SULLIVAN SUBDIVISION, 8 WHITTAKER DRIVE, STRATHAM, NH

Re: Subdivision Plan Review – Sullivan
Tax Map 19, Lot No. 68
112 High Street, Stratham, NH
Our Reference No. 1768

**RE: Engineer Response Letter 3
Sullivan Subdivision
8 Whittaker Drive, Stratham, NH
JBE Project No. 13070.1**

DRAWING No.
A1
SHEET 2 OF 8
JBE PROJECT NO. 13070.1

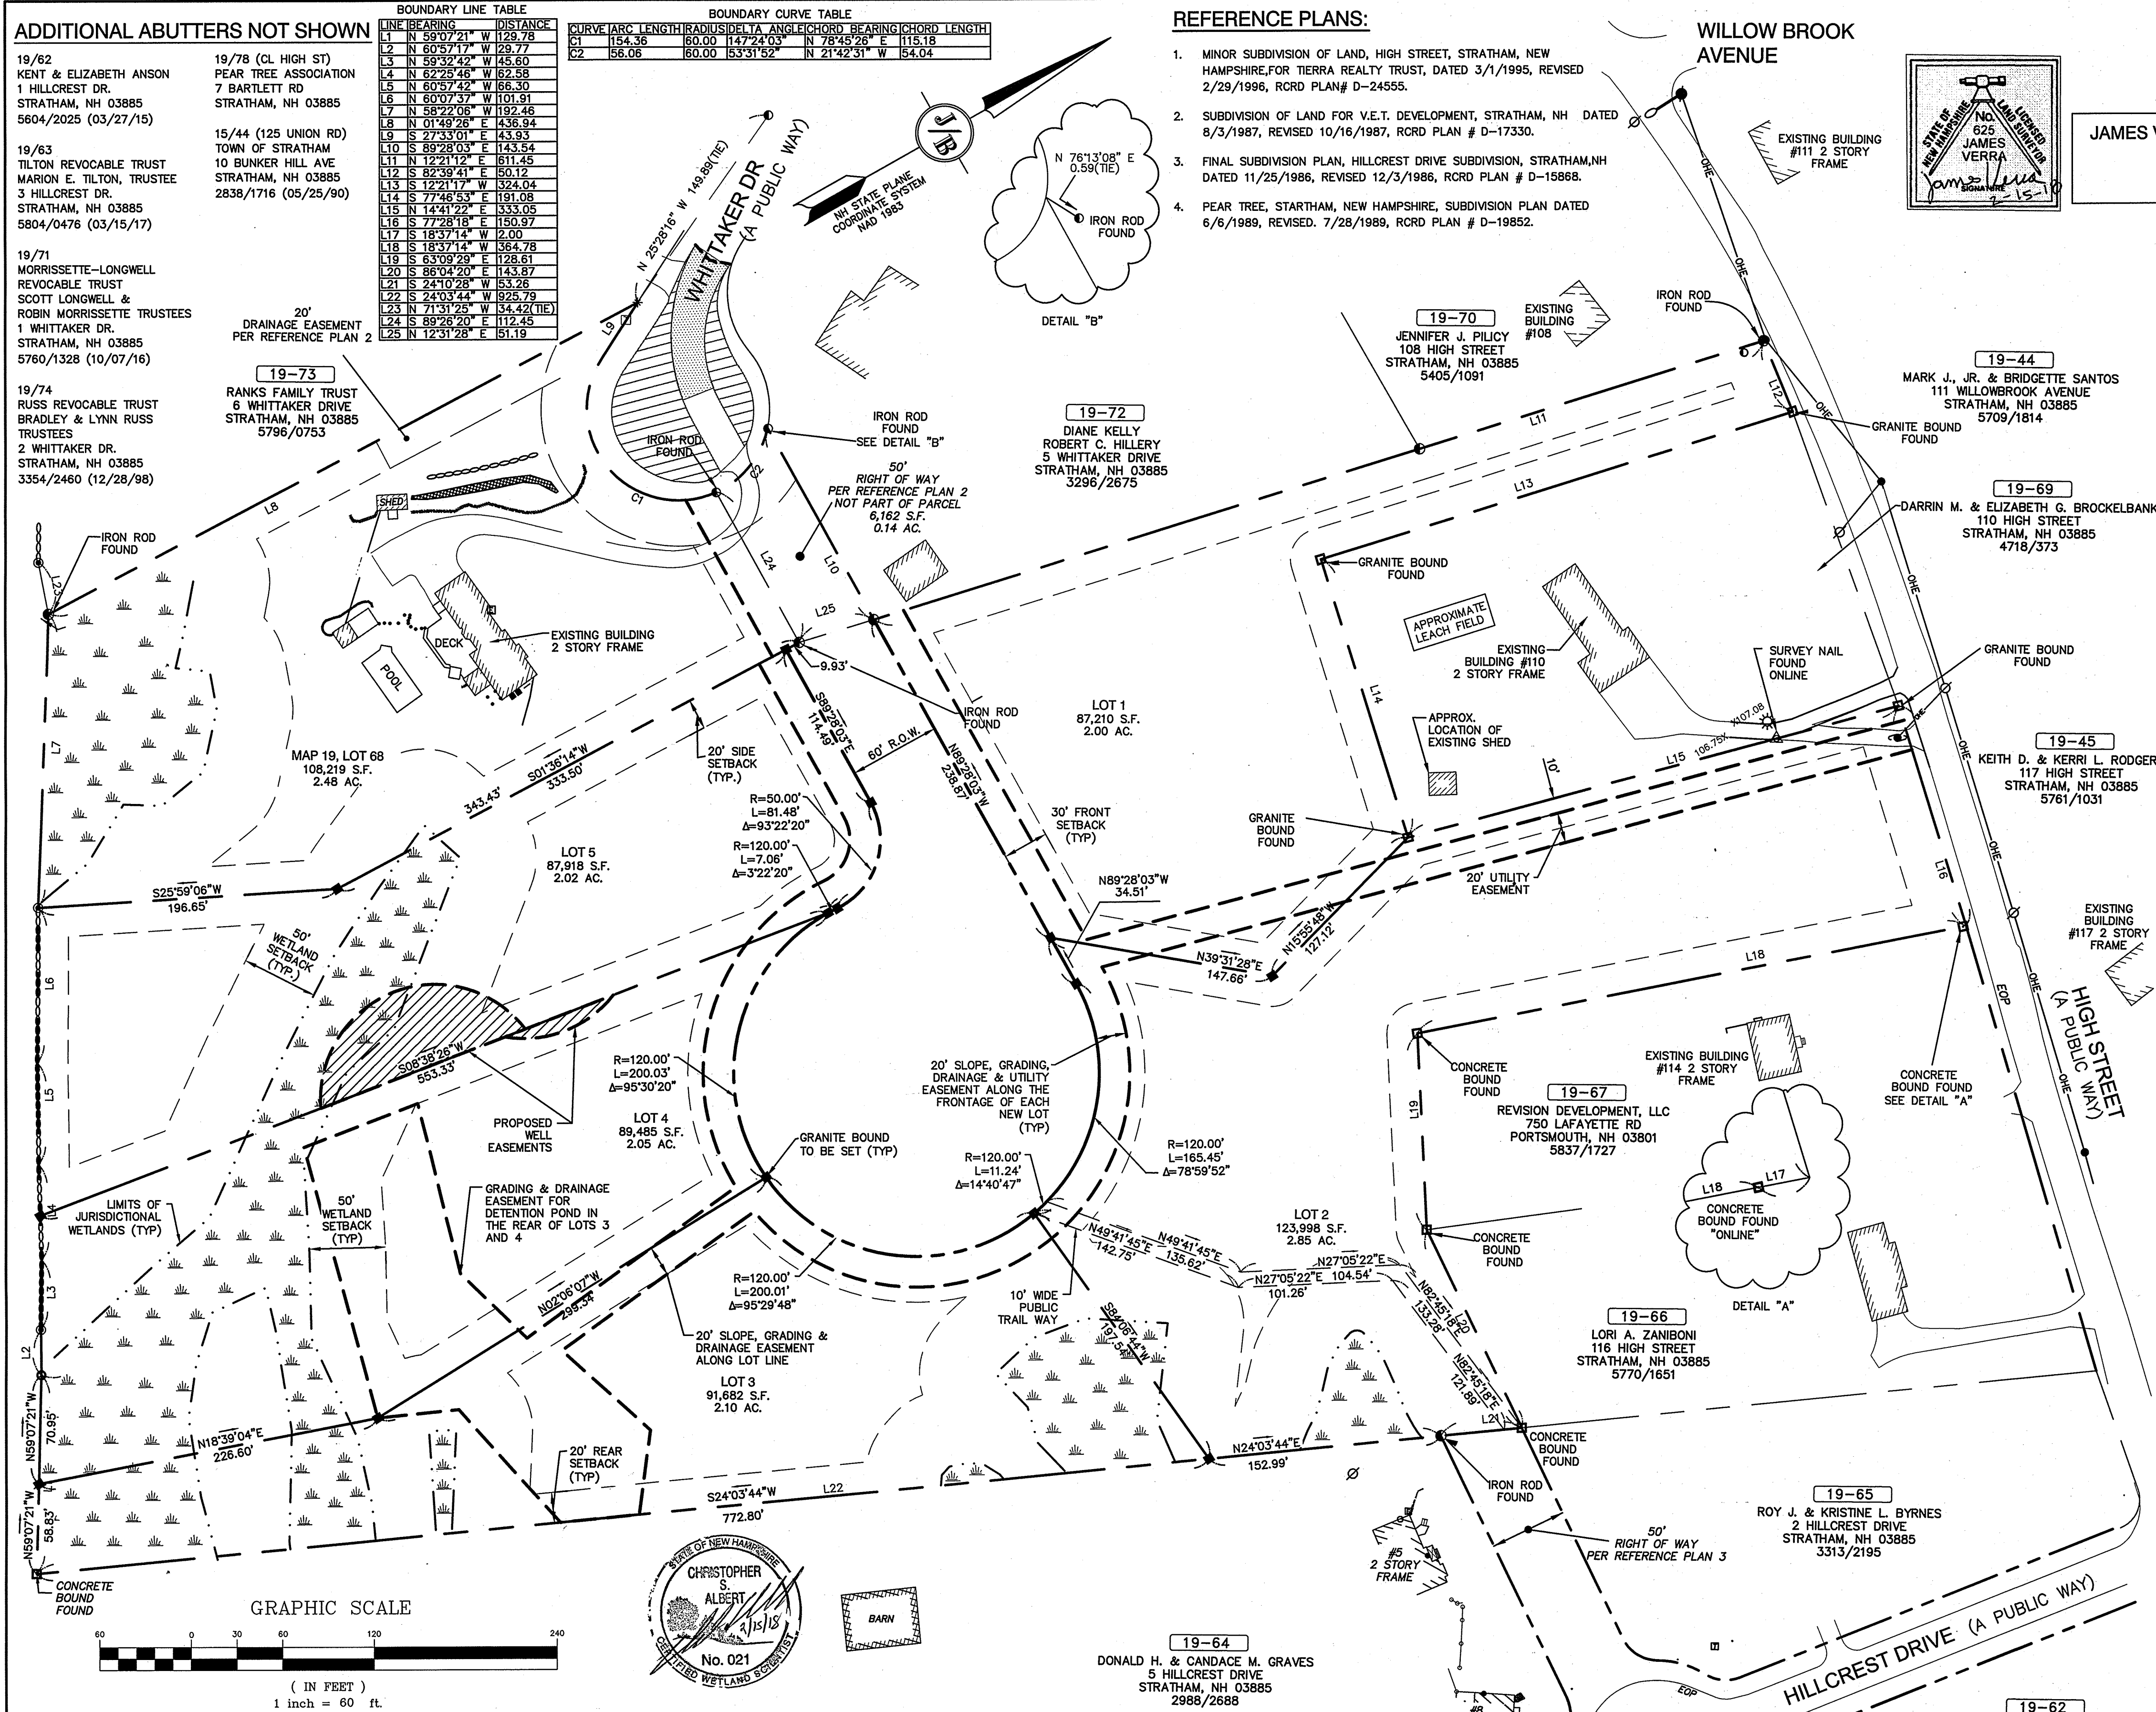
In one location, a replacement flag 'C7' was hung upslope and to the north of Mr. Albert's flag C7. (The new flag C7 is 32 feet from the old flag C7 and 54 feet from flag C6.)

We are in receipt of the Rockingham County Conservation District Wetland Review Letter dated January 29, 2018. The one wetland flag (C7) relocation has been done on the plans (Lot 2).

Plan Name:	PLAN AND PROFILE
Project:	SULLIVAN SUBDIVISION 8 WHITTAKER DRIVE, STRATHAM, NH 03885
Owner of Record:	ROBIN SULLIVAN 8 WHITTAKER DRIVE, STRATHAM, NH 03885

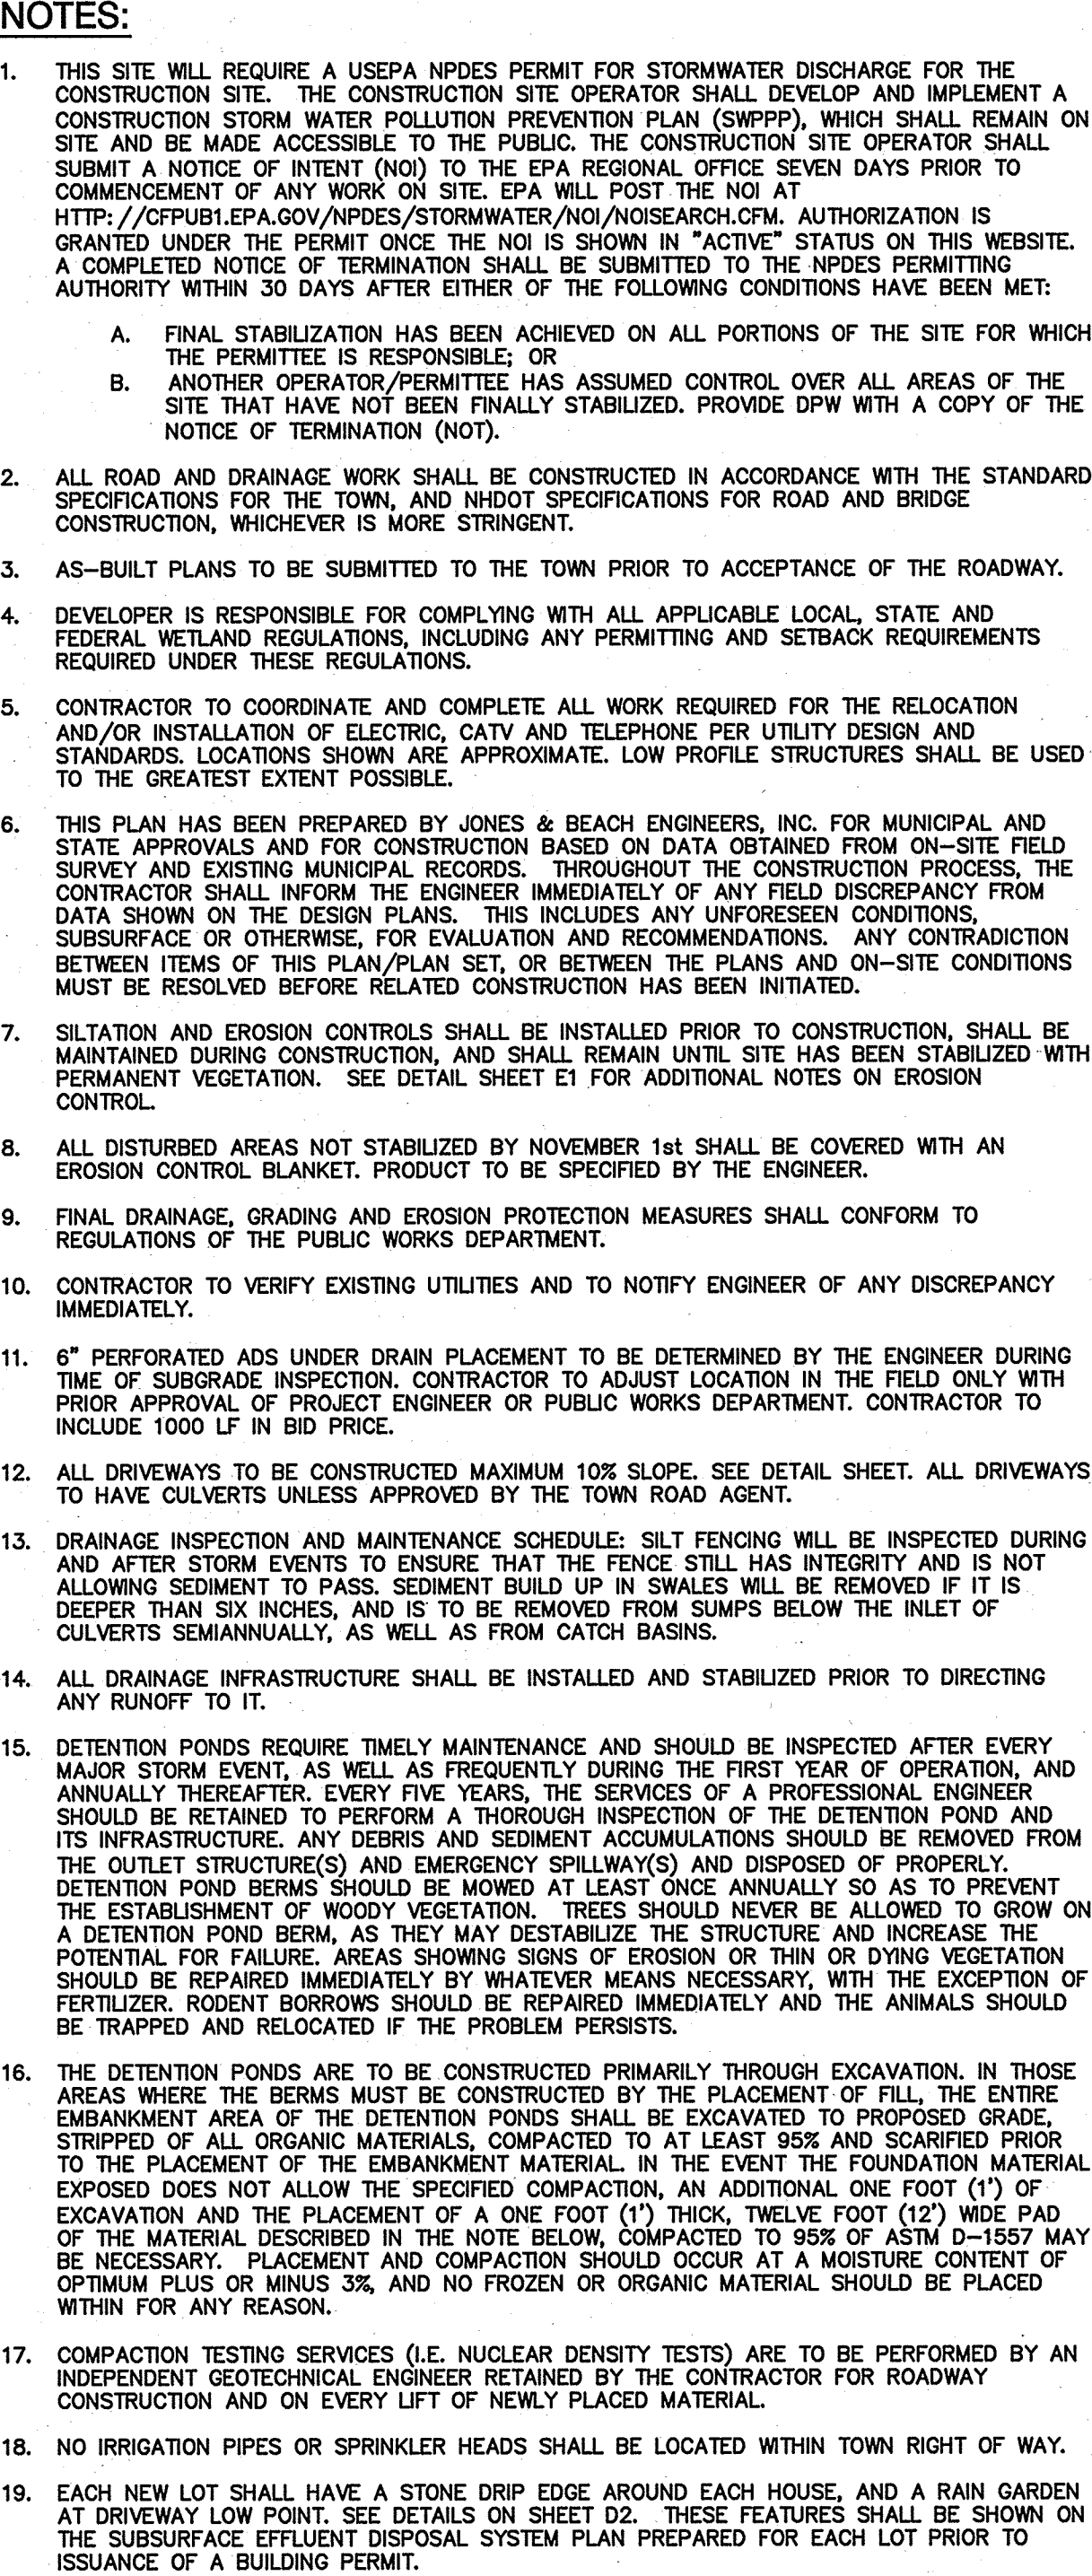
1. NHDES Subdivision Approval will be required for this subdivision proposal.
2. It would seem appropriate to call for the removal of the existing 15" culvert at STA 0+30.

6. There is no outlet protection called for at the 12" RCP (inv. 80.0) at STA 0-50 RT or at the 12" RCP (inv. 79.7) at STA 8+65 LT.

2. *It would seem appropriate to call for the removal of the existing 15" culvert at STA 0+30.*
RESPONSE: The existing 15" CMP will be removed.

RESPONSE: Rip rap stone has been specified at the two locations referenced.
